Proposed Site Plan

drawing title
Reading Borough Council
234 Southcote Lane
client / project

HTA-A_DR_0101
drawing number

FOR PLANNING
status

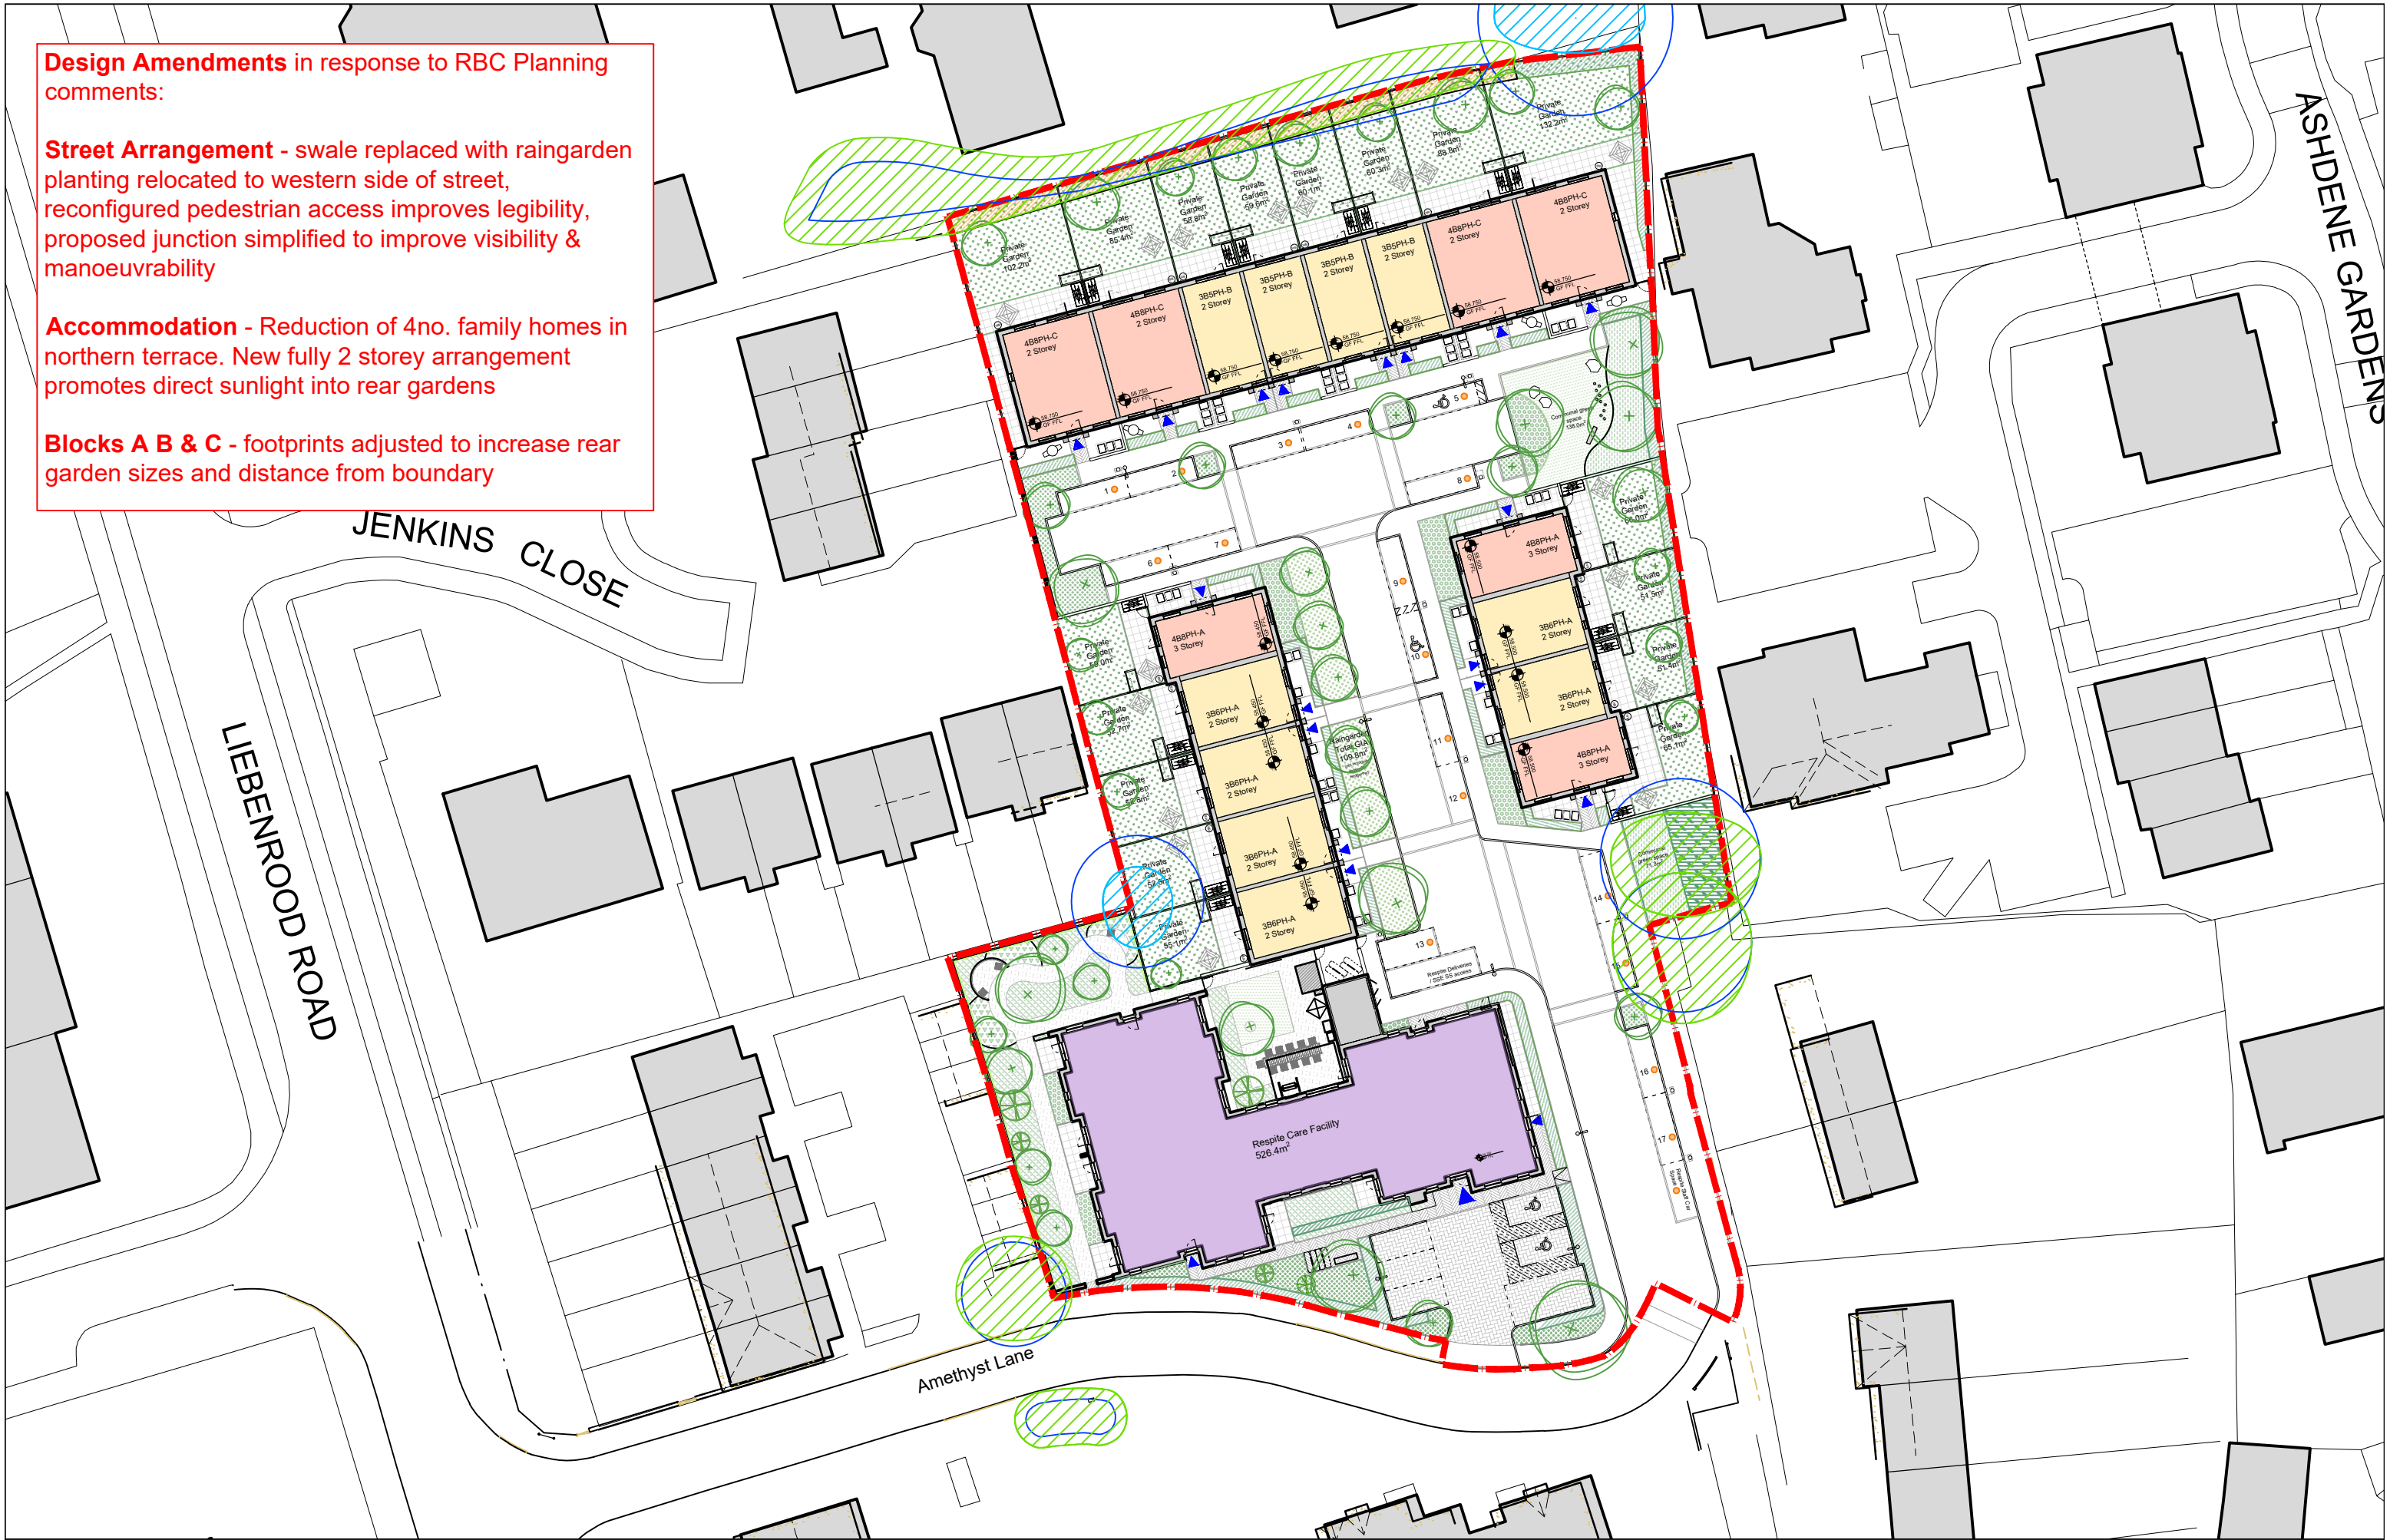
Design Amendments in response to RBC Planning comments:

Street Arrangement - swale replaced with raingarden planting relocated to western side of street, reconfigured pedestrian access improves legibility, proposed junction simplified to improve visibility & manoeuvrability

Accommodation - Reduction of 4no. family homes in northern terrace. New fully 2 storey arrangement promotes direct sunlight into rear gardens

Blocks A B & C - footprints adjusted to increase rear garden sizes and distance from boundary
